Product Update

The model 636 control board is now the replacement for model 635

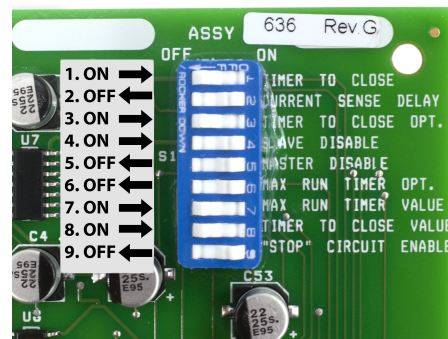
- This improvement has been made in order to allow the 636 to serve in both single and dual applications.

1. There is now a jumper plug inserted into the “SLAVE” motor port which allows for timer to close usage in single applications.
 - a. Removal of this plug is necessary for dual applications.
2. Dipswitch number four (4) “SLAVE DISABLE”, located on switch block S1, is now defaulted to “ON” from the factory for single application use.
 - a. This switch must be flipped to “OFF” for dual application use.
3. While the jumper plug is in place, LED’s D157 “SLAVE OPEN” and D158 “SLAVE CLOSE” will always be illuminated while pressing button S2 “LED ENABLE”.
